AMENDMENT NO. 2 NOVEMBER 2024

IS 16988 : 2018 COMPRESSED NATURAL GAS CYLINDER VALVE INTEGRATED WITH SOLENOID OPERATION (REMOTELY CONTROLLED) FOR AUTOMOTIVE USE — SPECIFICATION

ENLARGE DETAIL OF X

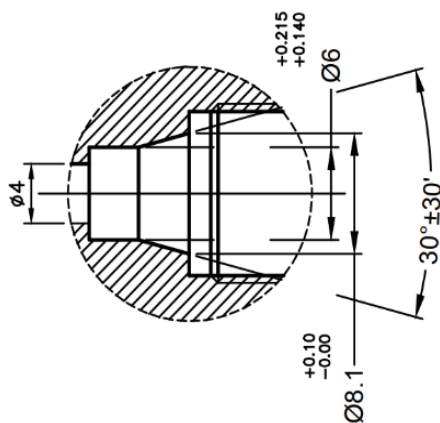
(Page 14, Outlet No. 21A) — Substitute the existing 'ENLARGED DETAIL AT X' by the following 'ENLARGED DETAIL AT X':

Kindly change highlighted to "AT"
